UNITED STATES PATENT AND TRADEMARK OFFICE

| APPLICATION NO. | FILING DATE | FIRST NAMED INVENTOR | ATTORNEY DOCKET NO. | CONFIRMATION NO. |
|-----------------|-------------|----------------------|---------------------|------------------|
| 10/684,469 | 10/15/2003 | Hitoshi Saito | SON-2836 | 8872 |

Office Action Summary

DETAILED ACTION

2]

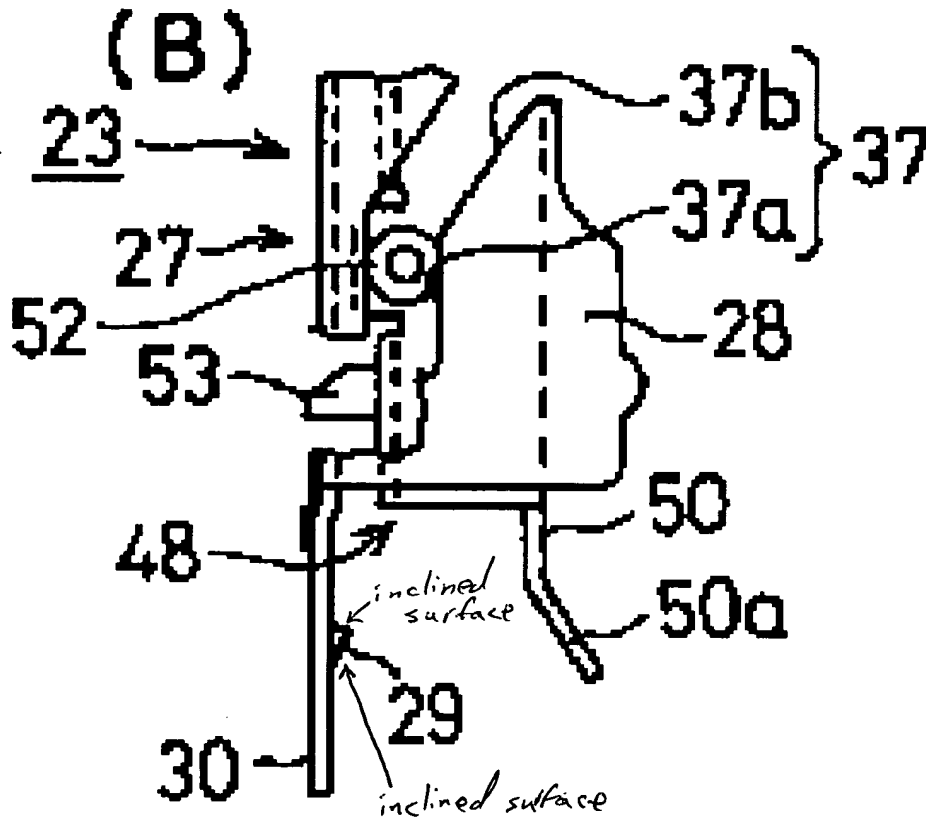
The applicant argues that "Suzuki fails to teach or suggest an engaging projection." This argument, however, is not found to be persuasive as Suzuki does teach an engaging projection (29). See FIGS. 3(A-B), for instance.

The applicant also contends that "as described in the specification on page 16, line 9, and in Figure 7, the engaging projection 23 is a trapezoidal shape as viewed from the side and has a central horizontal part 23a, a front-side inclined surface 23b extending downward from the end of the horizontal part 23a, and a rear-side inclined surface 23c extending downward to the rear from the rear end of the horizontal part 23a." This argument, however, is not found to be persuasive as the claims do not call

for the engaging projection to be a trapezoidal shape as viewed from the side and have a central horizontal part, a front-side inclined surface extending downward from the end of the horizontal part, and a rear-side inclined surface extending downward to the rear from the rear end of the horizontal part. See 37 CFR § 1.111(b). The claims merely set forth that "an inclined surface is formed at said engaging projection." Suzuki teaches an inclined surface (see attached Exhibit A of FIG. 2(B)) is formed at a engaging projection (29).
